Technical Service Bulletin: TSB190001

Released Date: 09-May-2019

Dedicated Fuel Pump Lubricating Oil Filter Introduction

Figure 4, Extension Wiring Harness Connection.

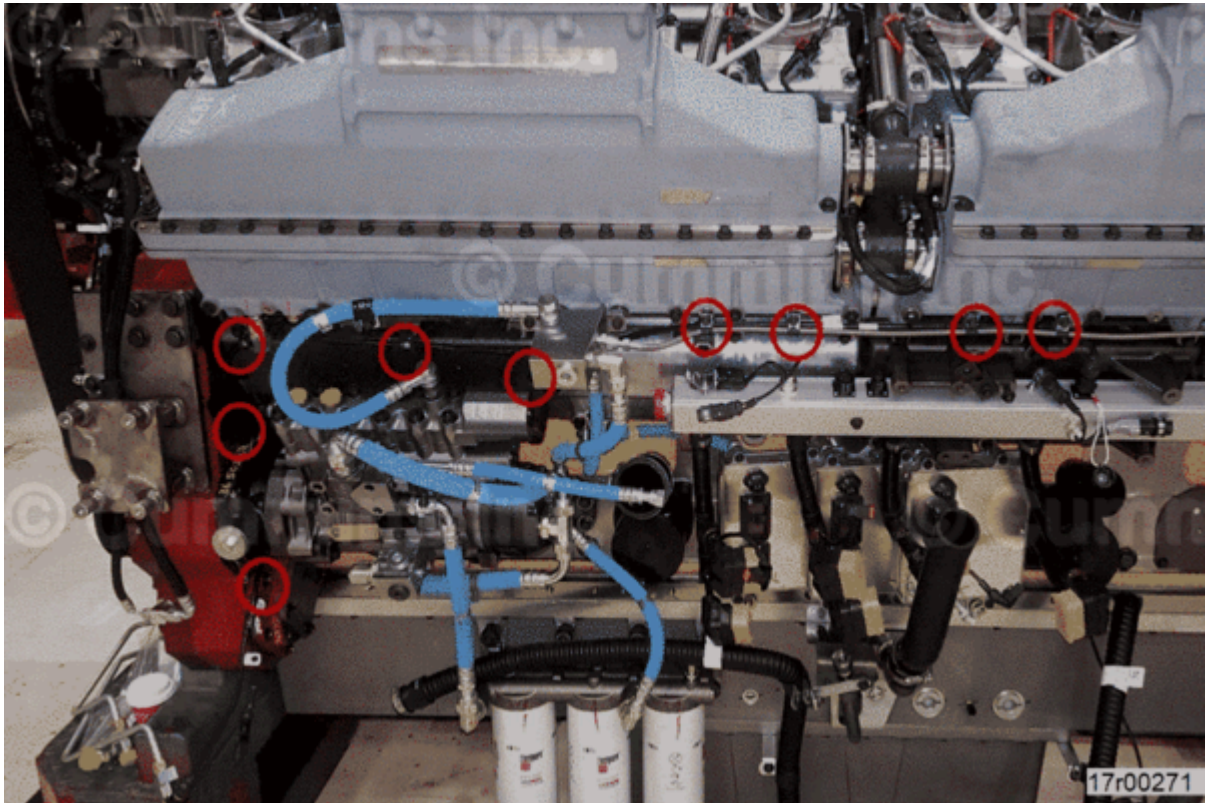
1. Connect new wiring harness extension to main left bank wiring harness. See Figure 4 above.

Figure 5, P Clip Locations.

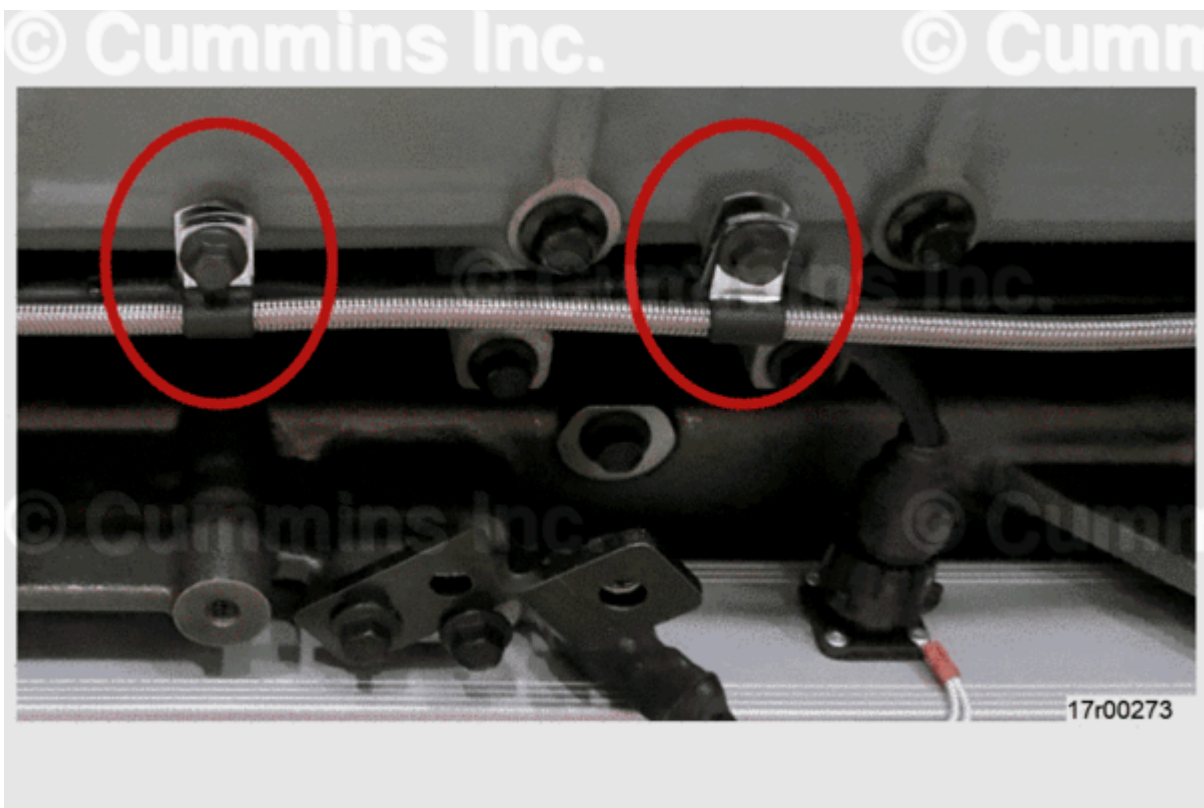
2. Install two new p-clips with capscrews to aftercooler bolt holes in an inboard orientation. Verify wiring harness is **not** interfering with surrounding components. See Figure 5 above.
3. Torque capscrews to 33N•m [24ft-lb]

Figure 6, P Clip Locations.

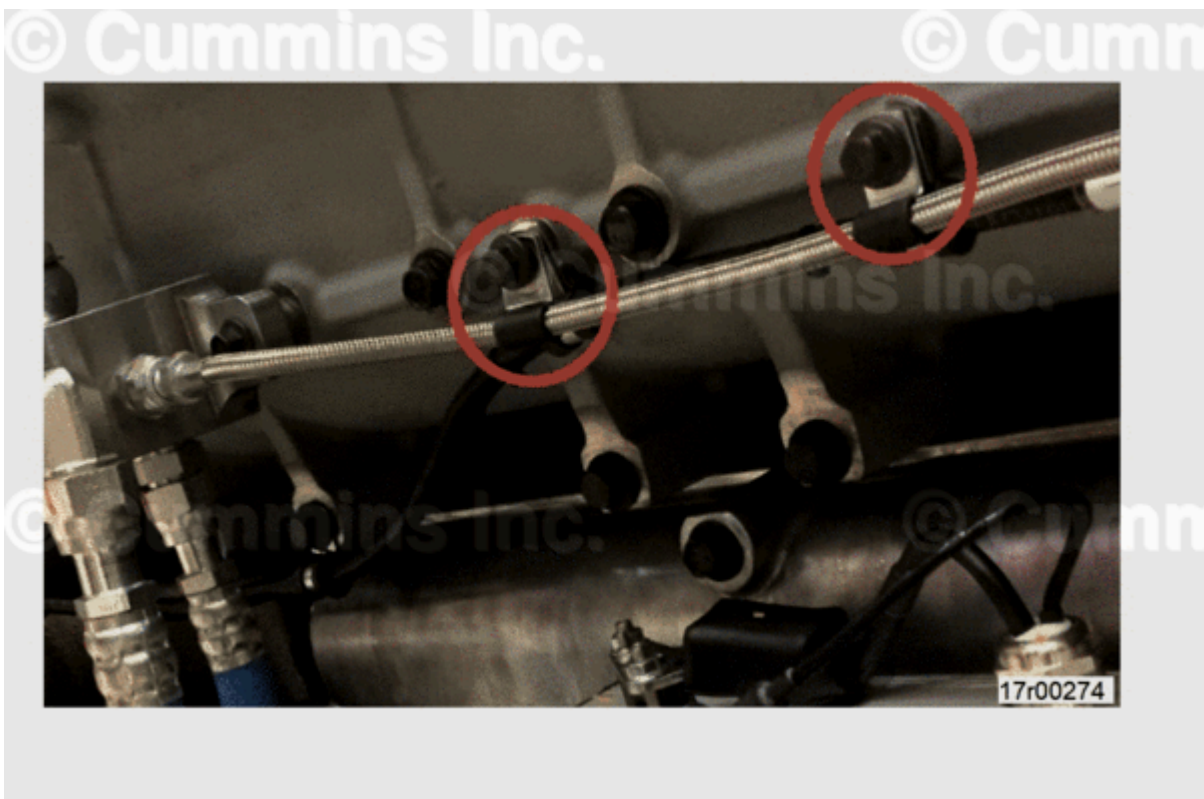
4. Install two new p-clips with capscrews to aftercooler bolt holes in an inboard orientation. Verify wiring harness is **not** interfering with surrounding components. See Figure 6 above.
5. Torque capscrews to 33N•m [24ft-lb]

Figure 10, P Clip Locations.

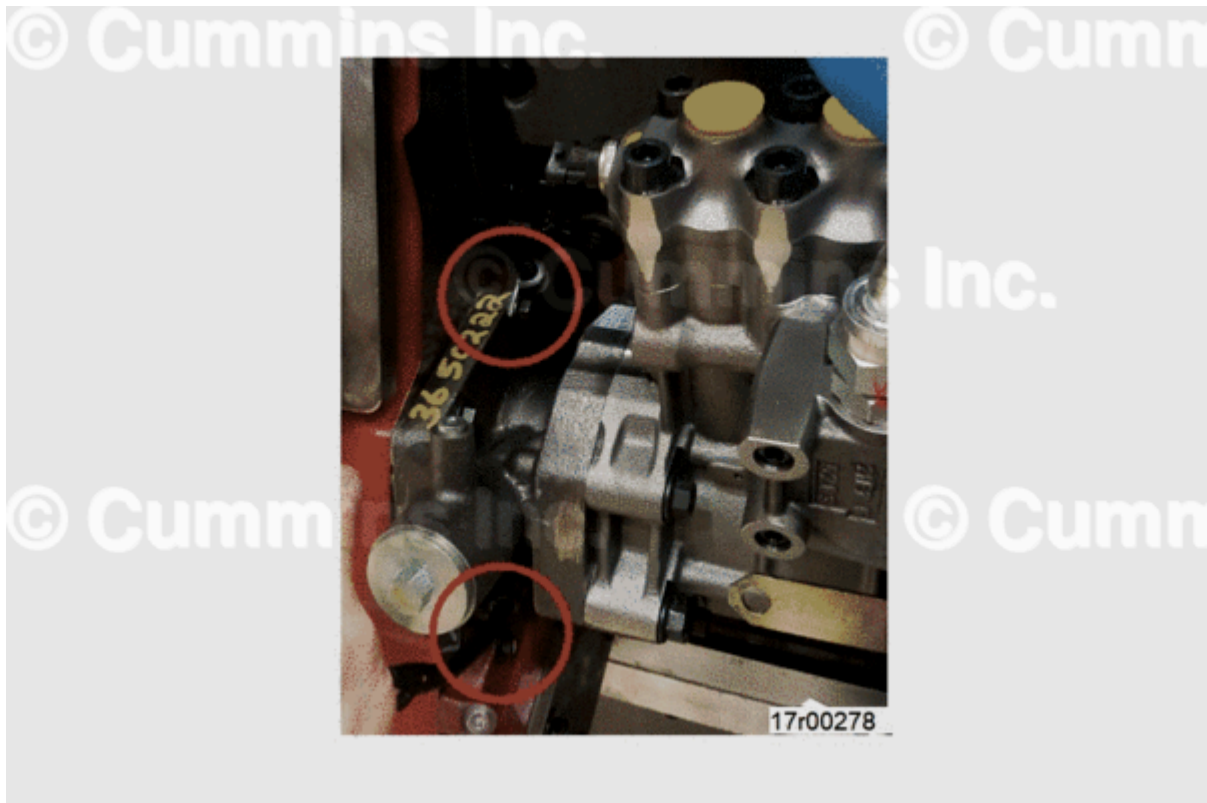
12. Install two new p-clips with capscrews to aftercooler bolt holes in an inboard orientation. Verify wiring harness is **not** interfering with surrounding components. See Figure 10 above.

13. Torque capscrews to 45N•m [33ft-lb]

Figure 11, O-ring Ports.

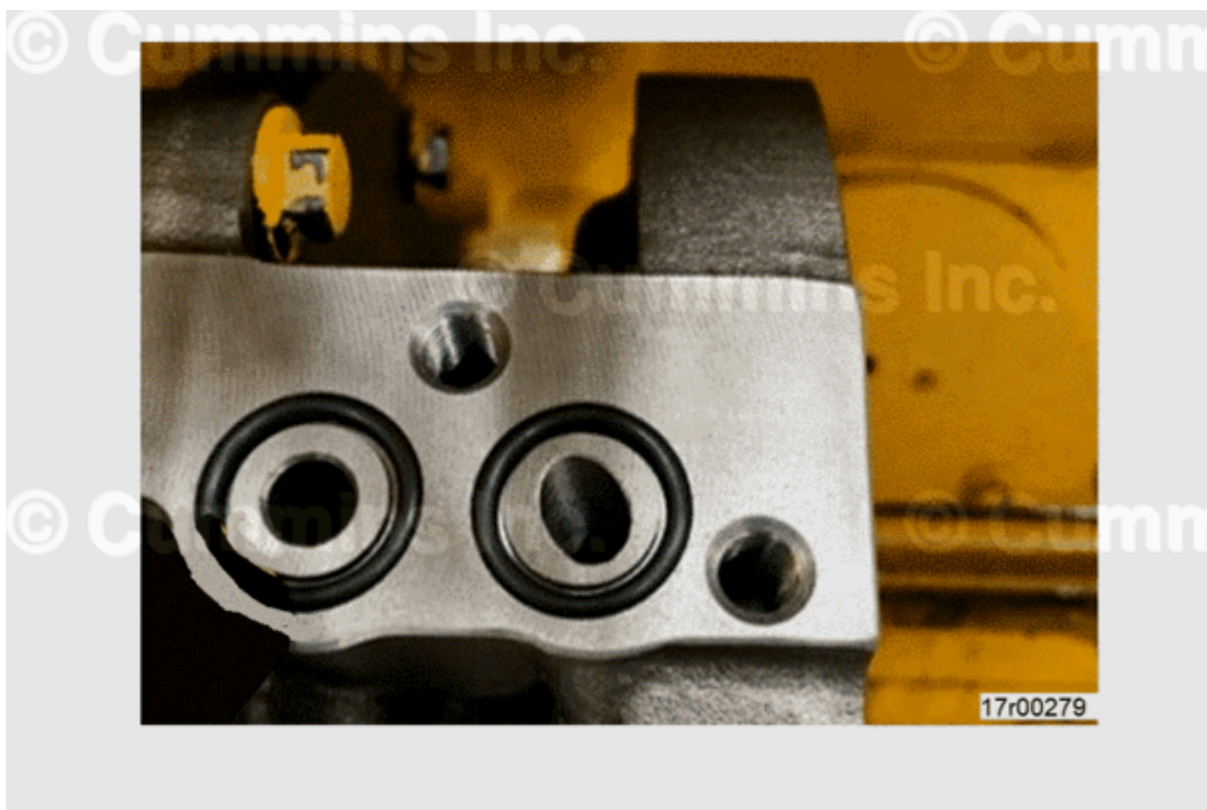
1. Install o-rings in accessory drive support. See Figure 11 above.

Figure 12, Capscrew Locations for Installation of Fuel Pump Lubricating Oil Filter Head.

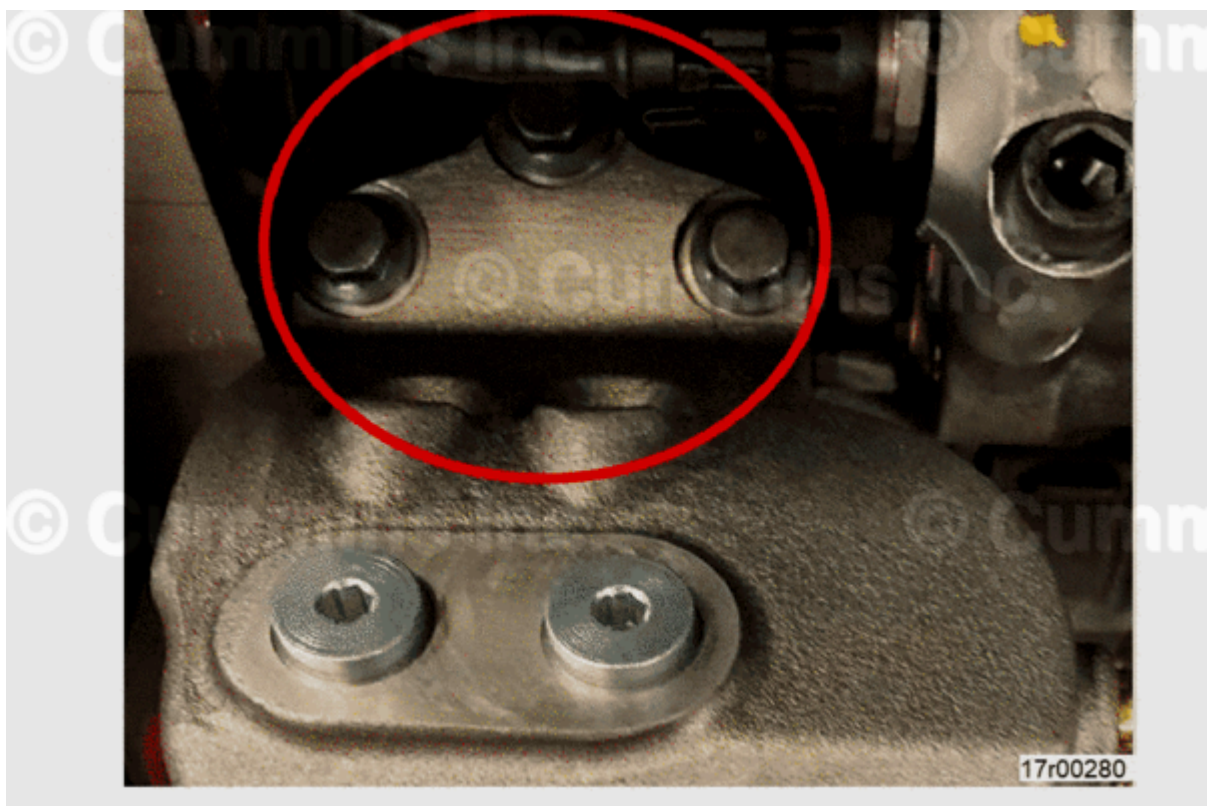
2. Install fuel pump lubricating oil filter head to fuel pump with three capscrews. See Figure 12 above.

3. Torque capscrews to 46N•m [33ft-lb]

Figure 13, Port Plug Locations on Fuel Pump Lubricating Oil Filter Head..

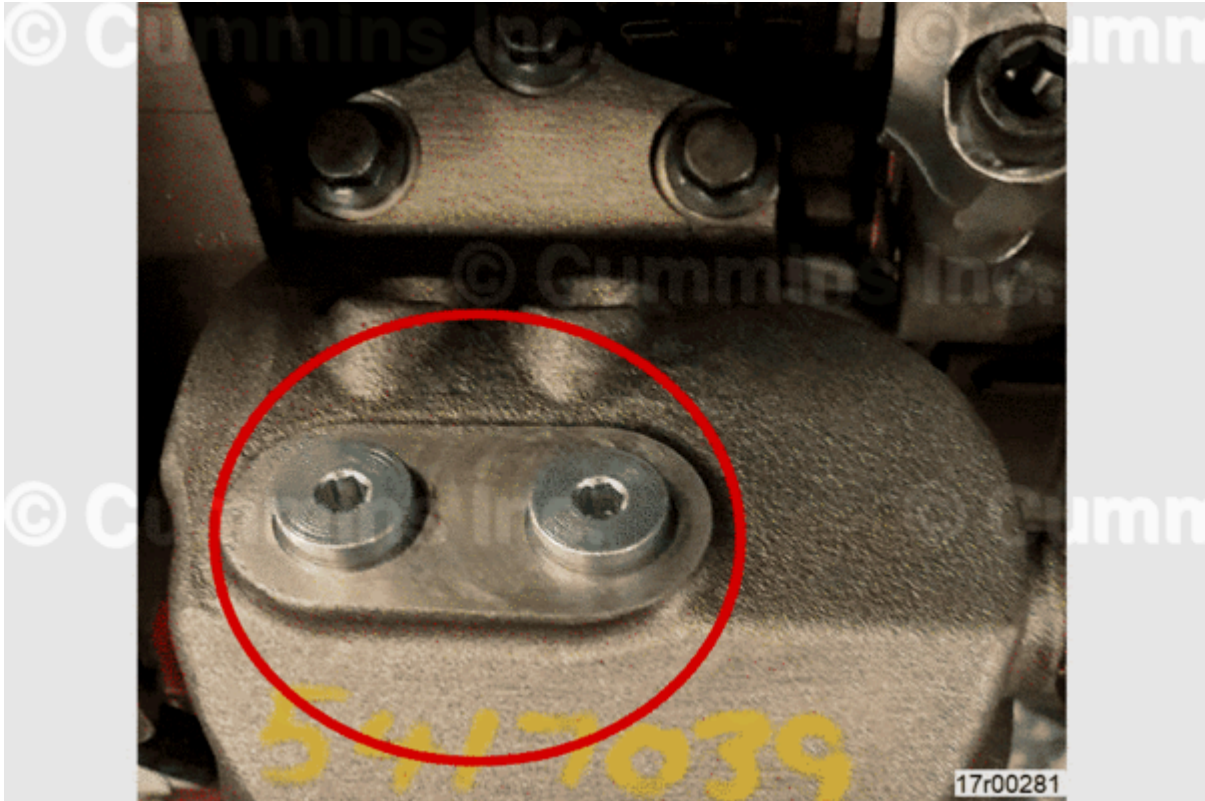
4. Install port plugs into top of fuel pump lubricating oil filter head. See Figure 13 above.

5. Torque to 11N•m [8ft-lb]

Figure 14, Primary Lubricating Oil Pressure Sensor Location.

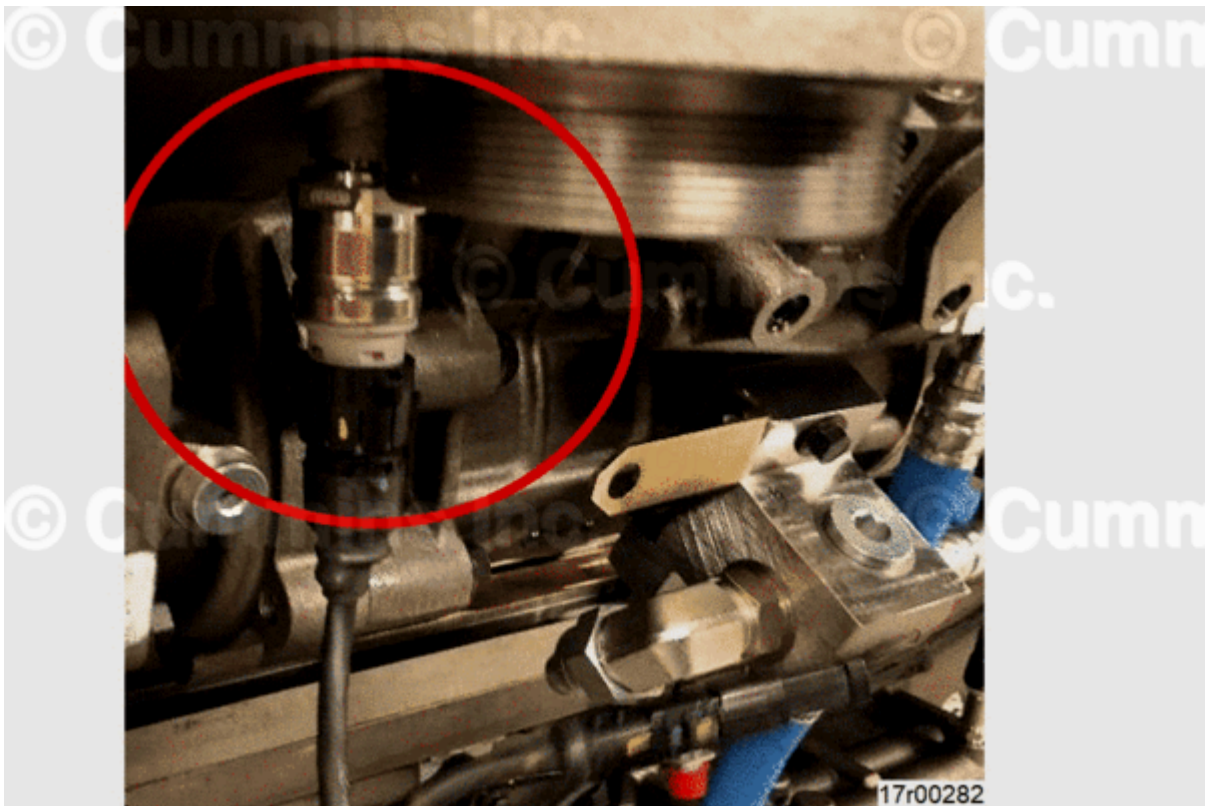
6. Install primary lubricating oil pressure sensor behind filter location in lubricating oil fuel pump lubricating oil filter head. See Figure 14 above.

7. Torque to 11N•m [8ft-lb]

Figure 15, Secondary Lubricating Oil Pressure Sensor Location.

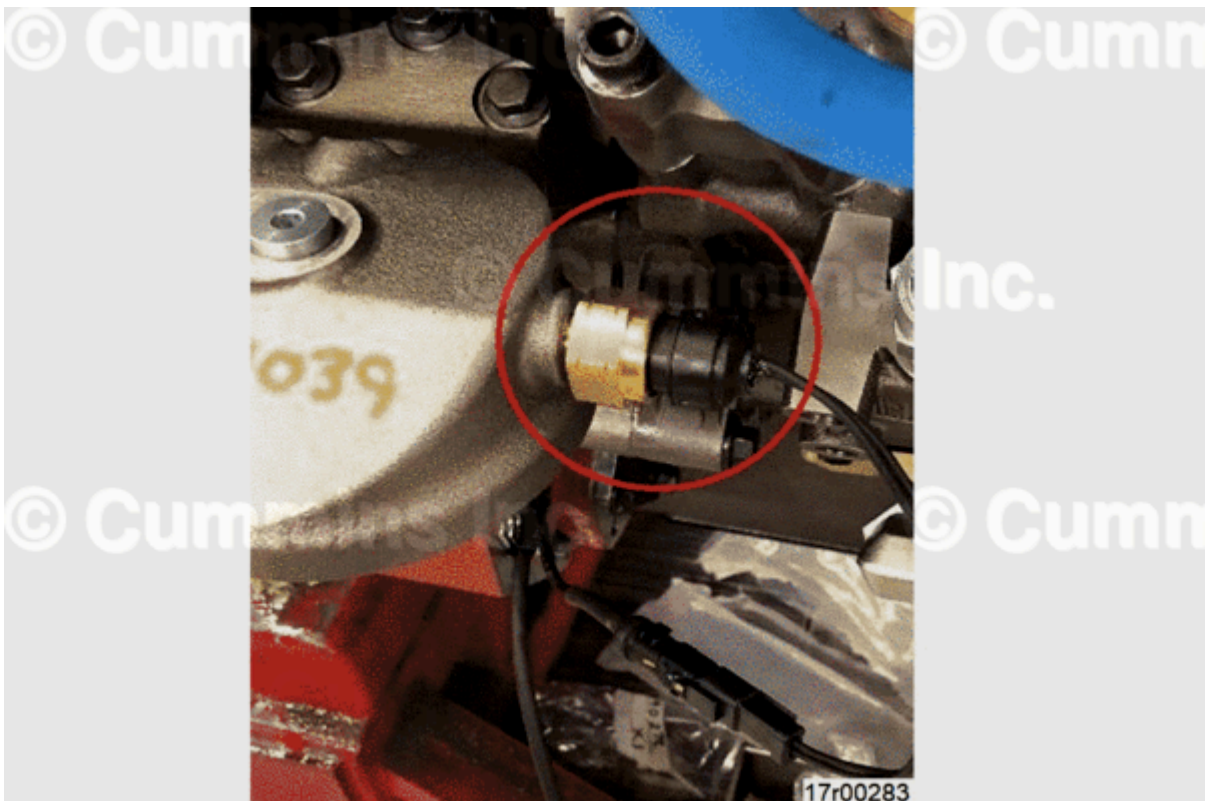
8. Install secondary lubricating oil pressure sensor behind filter location in location lubricating oil filter head. See Figure 15 above.

9. Torque to 11N•m [8ft-lb]
